# CHD–ENVIRONMENTAL HEALTH DIVISION KW

## SEPTIC IMPROVEMENT PERMIT / AUTHORIZATION TO CONSTRUCT / OPERATION PERMIT / EXISTING SYSTEM

PIN # 4639200460

SITE ADDRESS: 108 Periwinkle Rd Mooresville NC 28117 | PHONE: 704-533-4276 | ALT. PHONE 704-405-6776

INITIAL SITE SKETCH

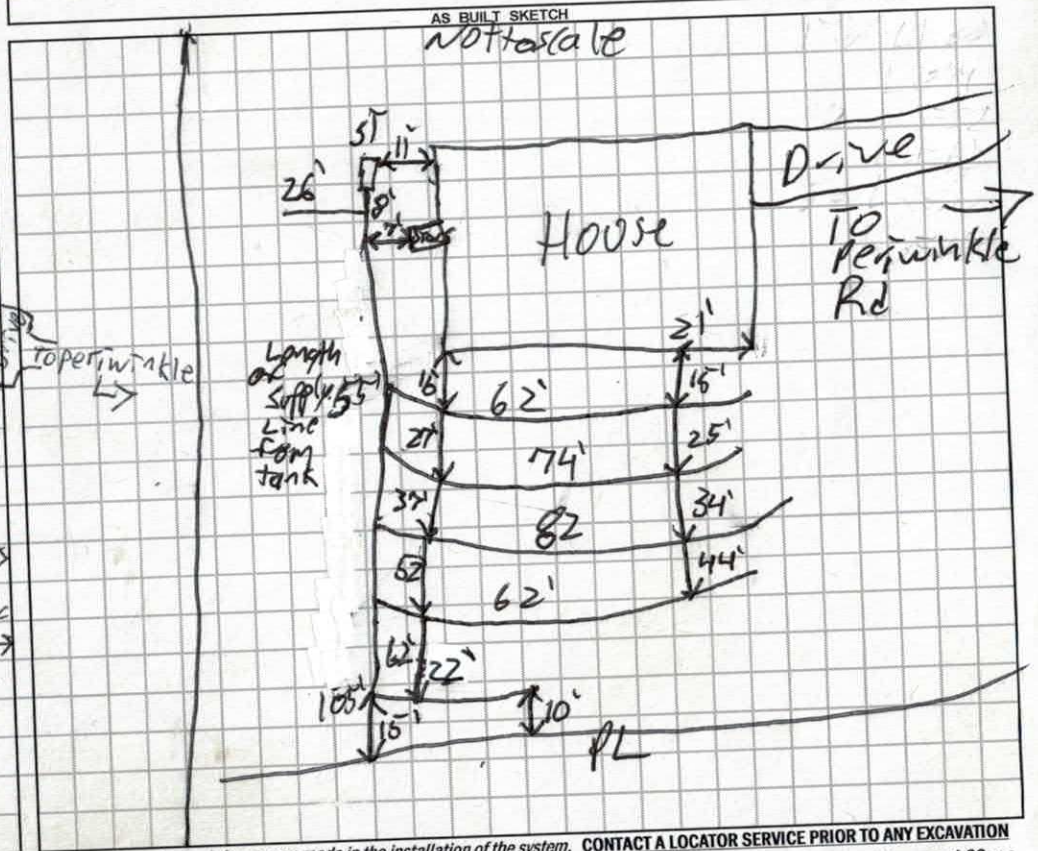
Comments / Conditions: Any Foundation drains must be directed away from system and out front side of House, Install lines on Contour, Fill shallow Gully next to nitrification Field, well needs to be 100' of any Part of septic system, If any fill has drained onto system it needs to be removed, Do Not Drive on, place material or manipulate septic area in any way

INITIAL SITE SKETCH

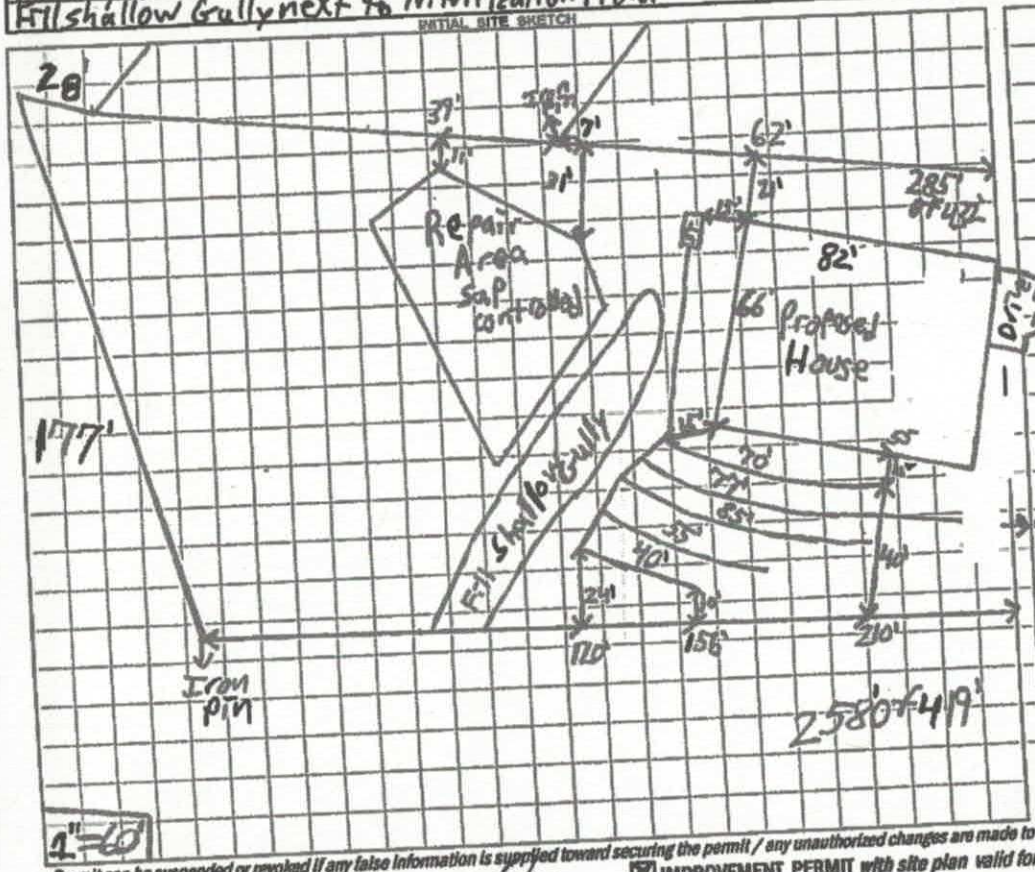
Comments / Conditions: Any Foundation drains must be directed away from system and out the front side of House. Install lines on contour. Fill shallow Gully next to Nitrification Field.

Well needs to be 100' off any part of septic system

INITIAL SITE SKETCH

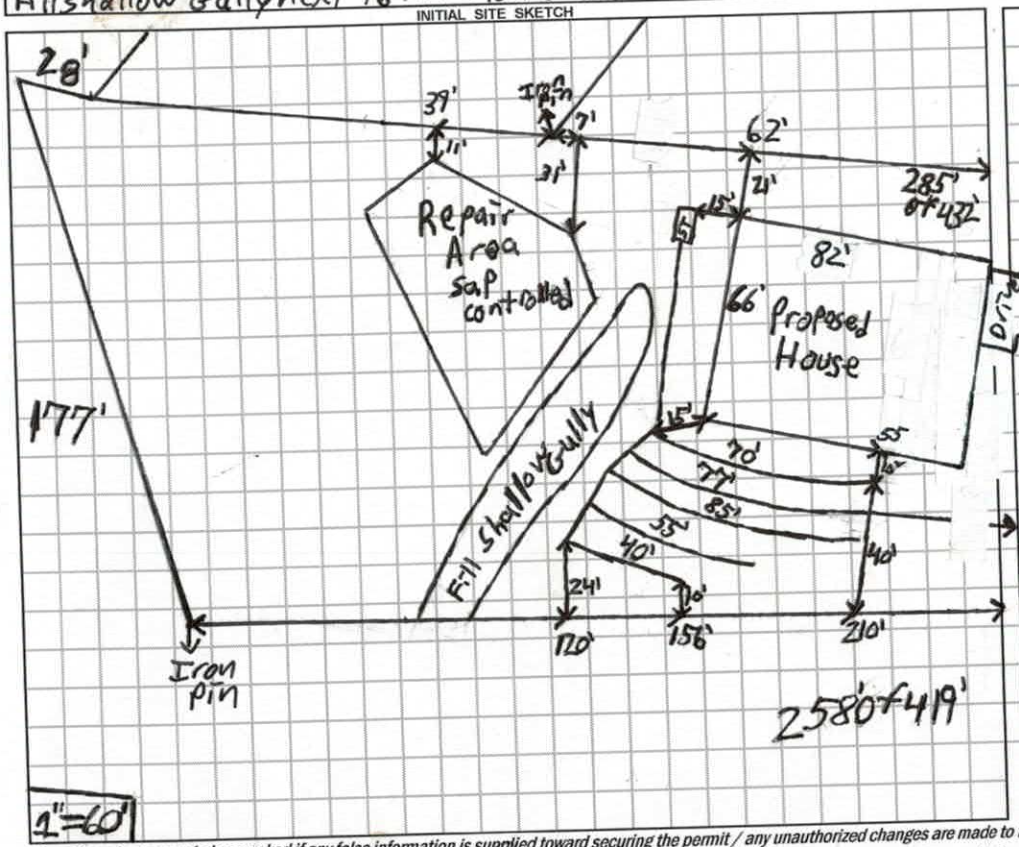
Comments / Conditions: Any Foundation drains must be directed away from system and out the front side of House. Install lines on contour. Fill shallow Gully next to Nitrification Field.

Well needs to be 100' off any part of septic system
